BCA ASSESSMENT REPORT

**Oakdale West Estate, Kemps Creek
Building 4C & 4D**

**Prepared For:
Goodman Property Services Pty Ltd**

Revision 3

Figure 1 – 4C & 4D Perimeter Vehicular Access per BCA C2.4

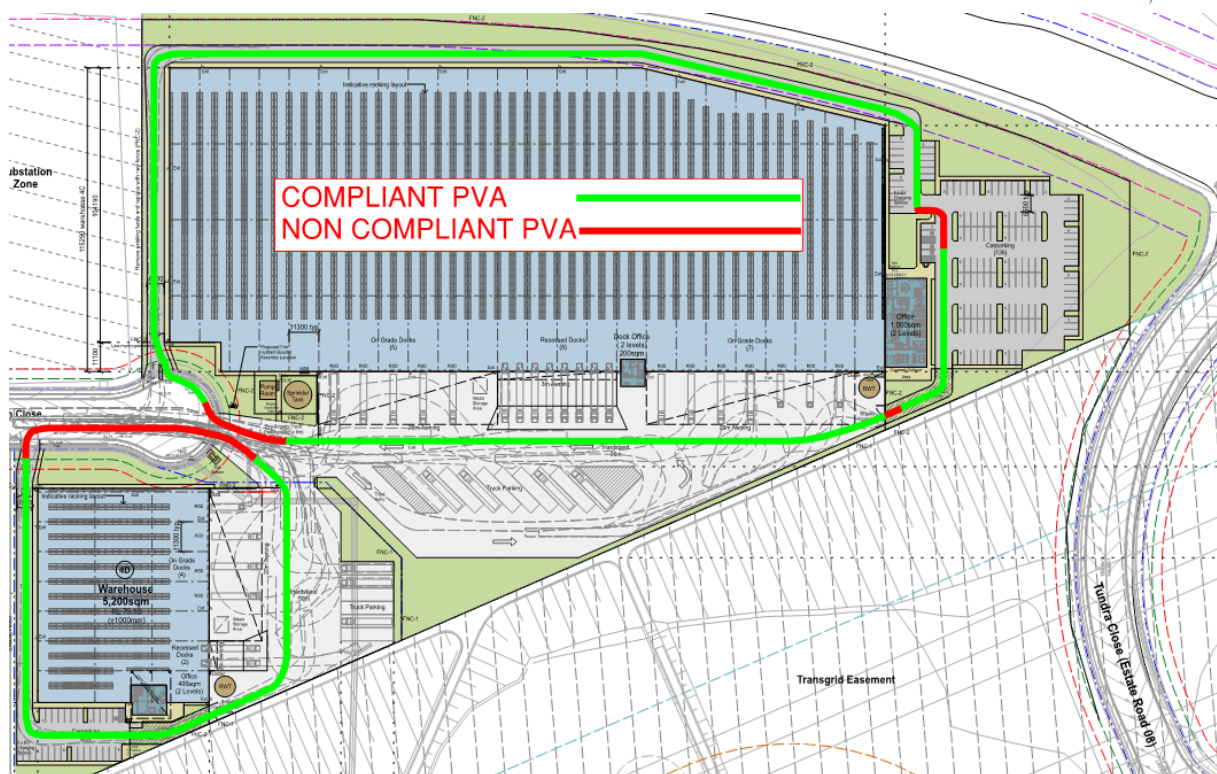
Comments: The proposed buildings do not comply with the provisions of C2.4 and thus the following non-compliance areas are identified on the site plan that are required to be addressed as a Performance Solution by the Fire Safety Engineer:

Site 4C:

- The furthest part of the vehicular access path is greater than 18m from the external wall:
 - Around the South-Eastern corner of the building around the truck entry.
 - In the North-Eastern corner around the permeable paving.
 - Around the northern corner around the carpark.

Site 4D:

- The furthest part of the vehicular access path is greater than 18m along the western side of the building on Cuprum Close.

Note: It is understood that a Performance Solution is proposed to address the use of permeable paving for the fire trail along the Eastern Elevation of Building 4C. Details are to be included in the Fire Engineering Report prepared by an accredited Fire Engineer.

Note 1: The driveways providing vehicular perimeter access must be designed with adequate loading capacities to withstand a fire truck and the gradients of the ramps should take into consideration to the FRNSW Policy 4 Vehicular Access Guideline.

Note 2: If the perimeter access paths are reduced to less than 6m in width to accommodate pedestrian egress paths per Clause D1.10 below, this will need to be documented in the Performance Solution.
